Highland Park DC Bylaw Changes

At time of 2nd reading propose the following amendments to the DC bylaws.

Bylaw 31D2017 (Attachment 3)

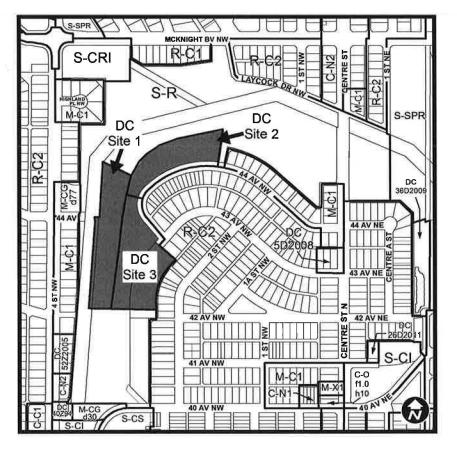
1. Delete the map in Schedule B and replace with a new map as follows:
